BUILDING CODE OF AUSTRALIA COMPLIANCE ASSESSMENT REPORT

RESIDENTIAL FLAT BUILDING WITH BASEMENT CARPARK

IVANHOE ESTATE - LOT C4, EPPING ROAD, MACQUARIE PARK

REPORT NO. ▶ 11067.3

Market Building
Level 1-16

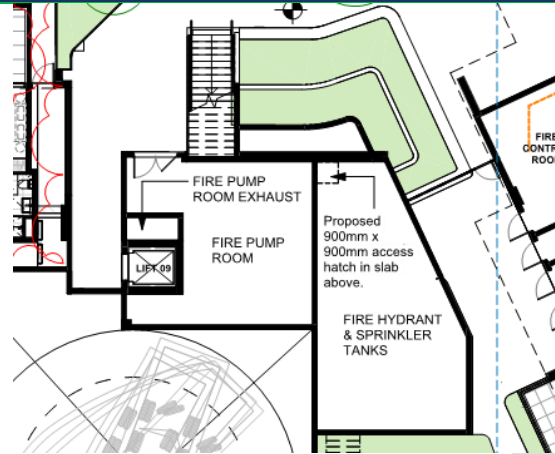
- The distance between alternative exits is less than 9m, being 5.1m.

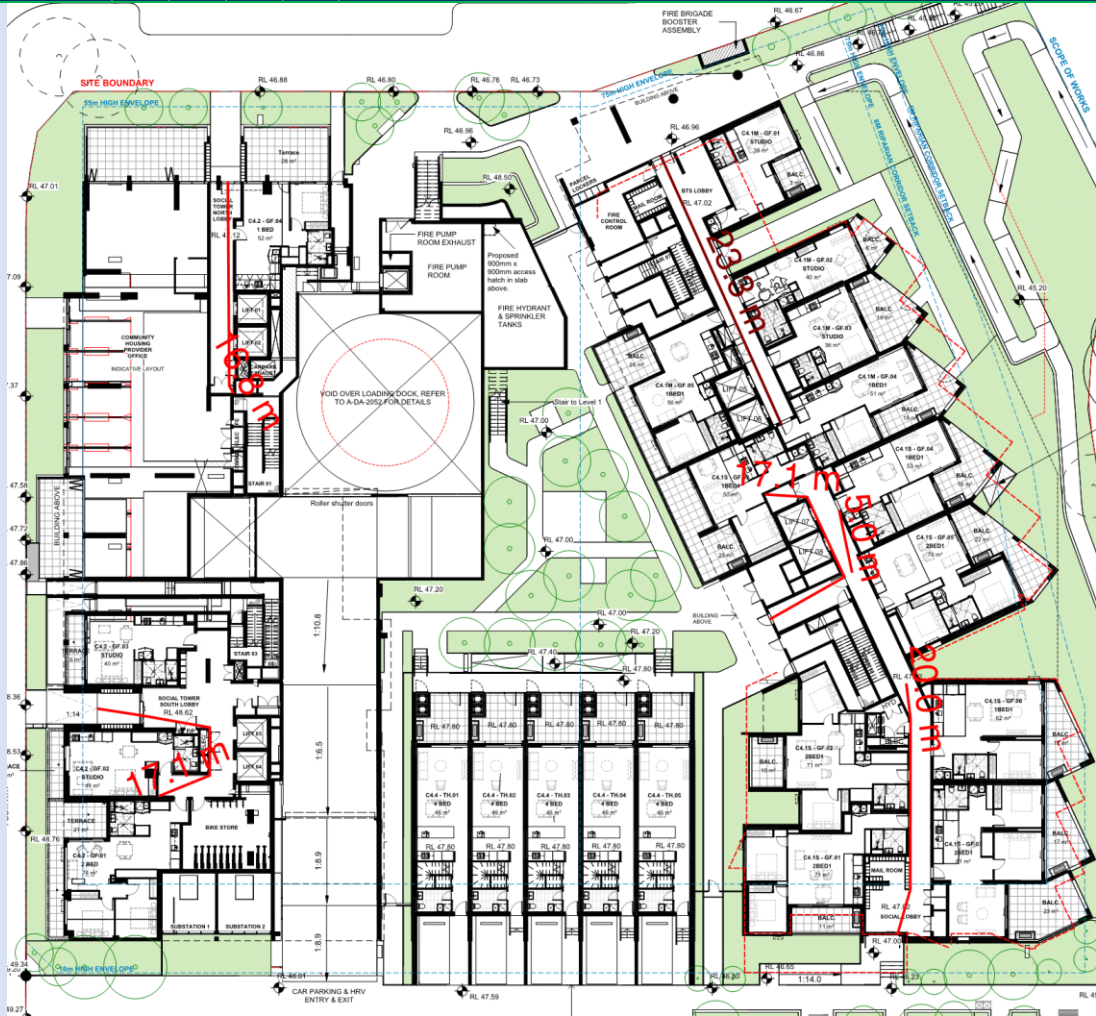
D2D5 Exit travel distances [2019: D1.4]		X			<p>(1) Class 2 and 3 buildings —</p> <p>(a) The entrance doorway of any sole-occupancy unit must be not more than—</p> <p>(i) 6 m from an exit or from a point from which travel in different directions to 2 exits is available; or</p> <p>(ii) 20 m from a single exit serving the storey at the level of egress to a road or open space; and</p> <p>(b) no point on the floor of a room which is not in a sole-occupancy unit must be more than 20 m from an exit or from a point at which travel in different directions to 2 exits is available.</p> <p>(3) Class 5, 6, 7, 8 or 9 buildings — Subject to (4), (5) and (6)—</p> <p>(a) no point on a floor must be more than 20 m from an exit, or a point from which travel in different directions to 2 exits is available, in which case the maximum distance to one of those exits must not exceed 40 m; and</p> <p>(b) in a Class 5 or 6 building, the distance to a single exit serving a storey at the level of access to a road or open space may be increased to 30 m.</p> <p><i>Details demonstrating compliance with this clause must be incorporated into the construction certificate plans / specification</i></p> <hr/> <p><u>COMPLIANCE COMMENTARY</u></p> <p>Basement 2</p> <ul style="list-style-type: none"> - Distance to an exit is greater than 40m, maximum being 54m.

Basement 2

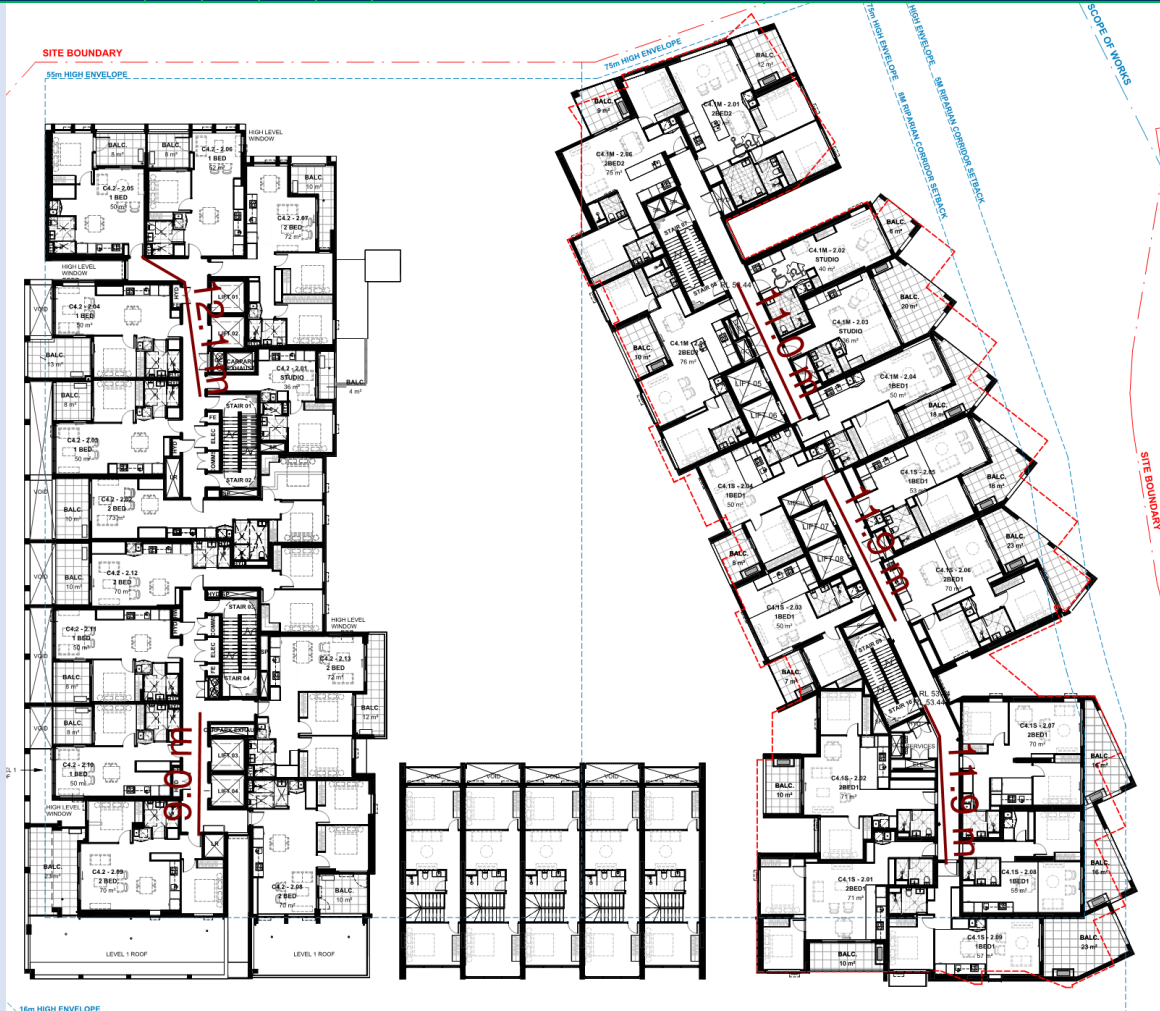
BCA DEEMED-TO-SATISFY PROVISION	COMPLIES	DOES NOT COMPLY	Informational NA or	Compliance Required	COMMENTS
					<p>Basement 1</p> <ul style="list-style-type: none"> - Distance to a point of choice is greater than 20m, maximum being 23m. - Distance to an exit is greater than 40m, maximum being 50m. <p>Ground Floor</p> <ul style="list-style-type: none"> - Distance to a point of choice is greater than 20m, maximum being 23m. <p>Level 1 -23</p> <ul style="list-style-type: none"> - Distance to a point of choice is greater than 6m, maximum being 11.9m.

Level 2 – 17

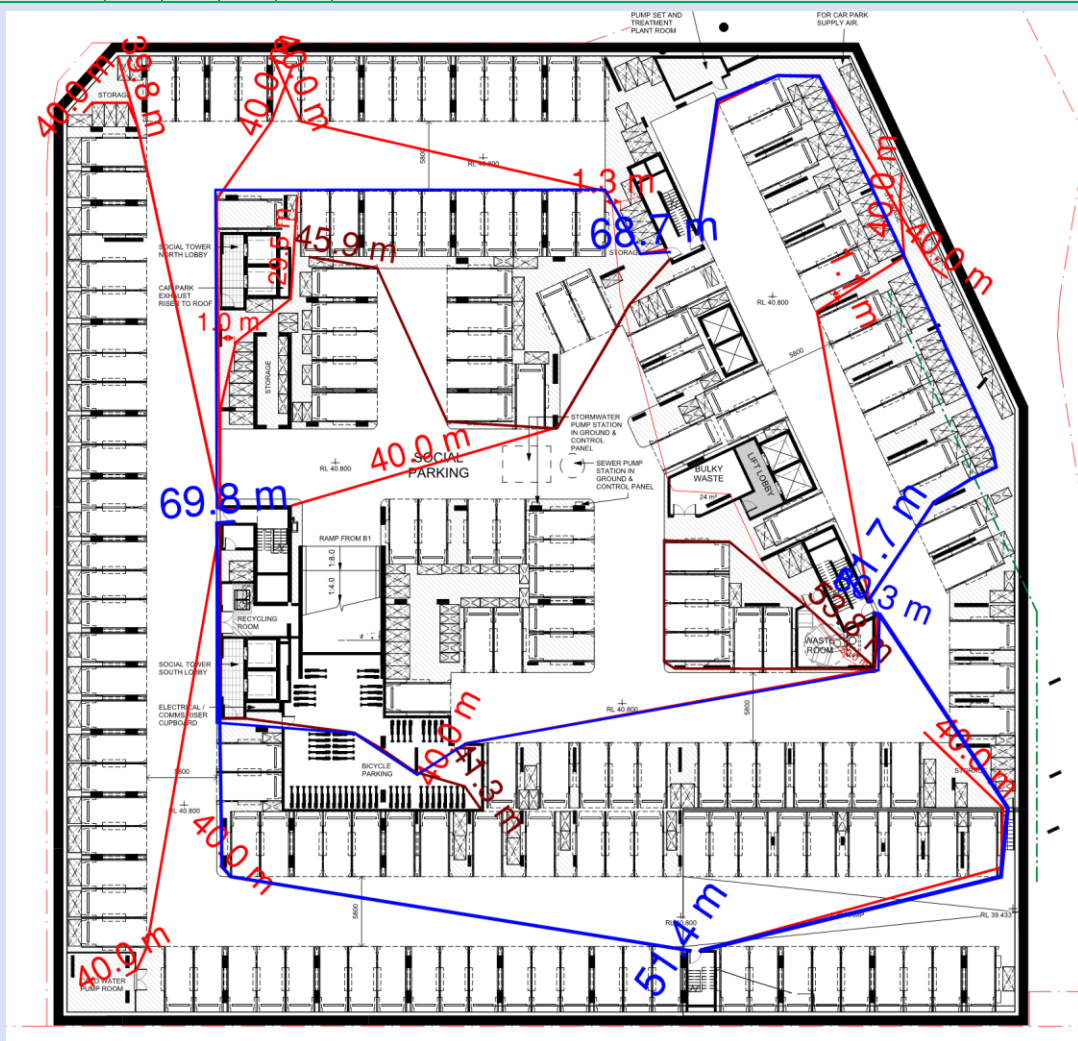
BCA DEEMED-TO-SATISFY PROVISION	COMPLIES	DOES NOT COMPLY	Informational NA or	Compliance Required	COMMENTS
					 <p style="text-align: center;">Level 18 - 23</p>
D2D6 Distance between alternative exits [2019: D1.5]		X			<p>Exits that are required as alternative means of egress must be—</p> <ul style="list-style-type: none"> (a) distributed as uniformly as practicable within or around the storey served and in positions where unobstructed access to at least 2 exits is readily available from all points on the floor including lift lobby areas; and (b) not less than 9 m apart; and (c) not more than— <ul style="list-style-type: none"> (i) in a Class 2 or 3 building — 45 m apart; or (iii) in all other cases — 60 m apart; and (d) located so that alternative paths of travel do not converge such that they become less than 6m apart. <p><i>Details demonstrating compliance with this clause must be incorporated into the construction certificate plans / specification</i></p> <p><u>COMPLIANCE COMMENTARY</u></p> <p>Basement 2</p> <ul style="list-style-type: none"> - The distance between alternative exits is greater than 60m, maximum being 80.3m.
